Addendum ADD-#02

Project Name: Energy Recovery and Dehumidification

Polar Project No. 2543

Issued Date: January 9, 2026

1 M7 P&ID - HEAT PUMP AND HYDRONIC INTEGRATION

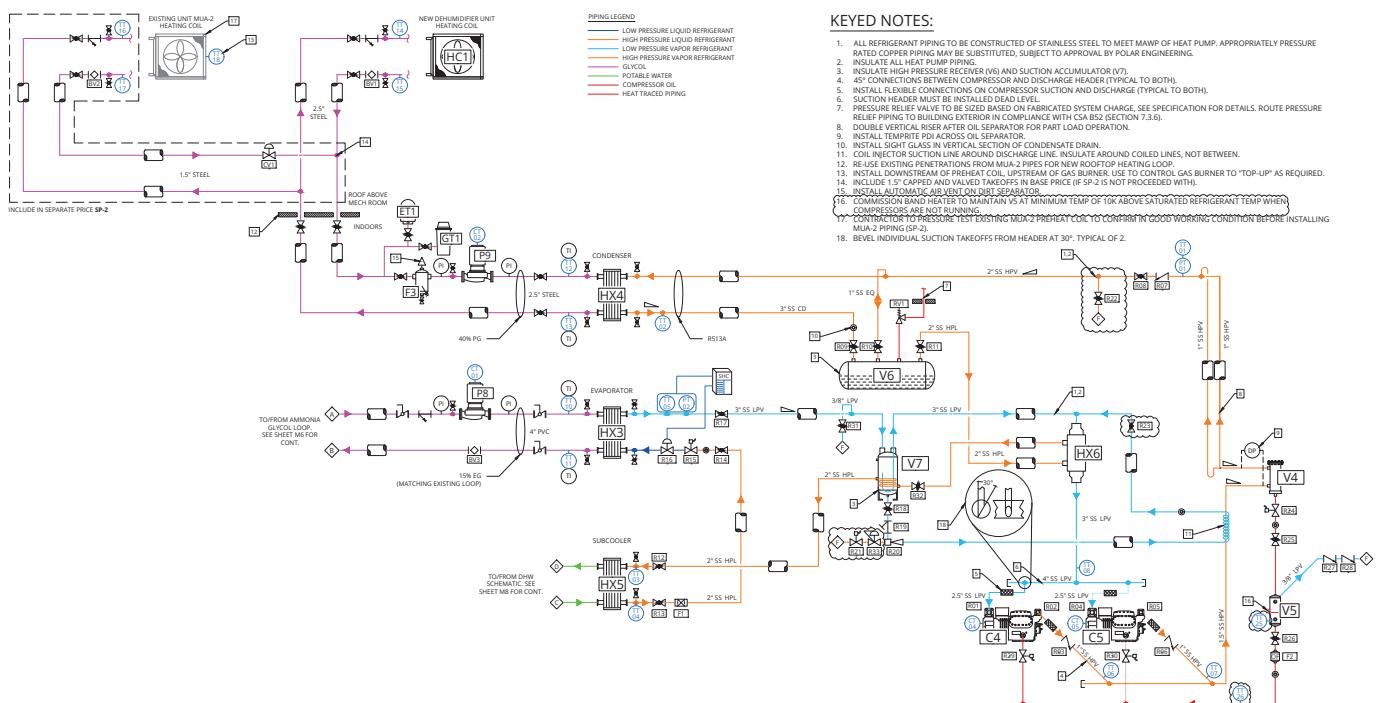
3.1 Mechanical Drawings Sheets M7, M9, and M10.

a. Revise as per the enclosed.

DRAWING NO.:
E1.01

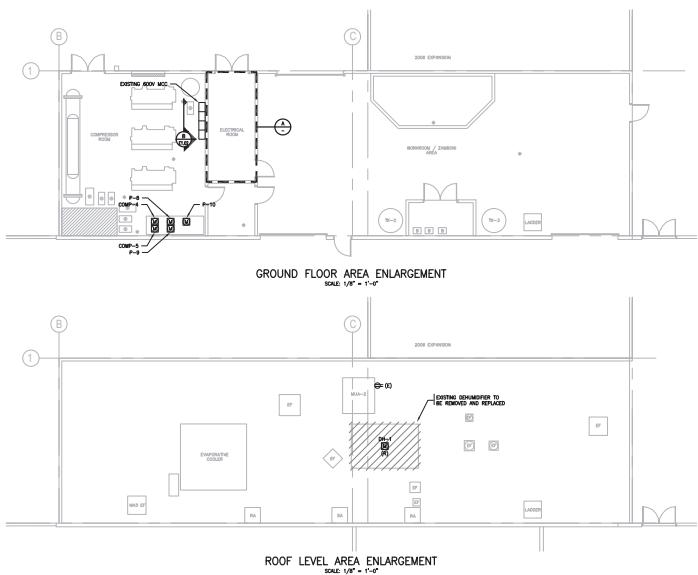
3.2 Electrical Drawings Sheet E1.01 Motor List.

a. Revise as per the enclosed.
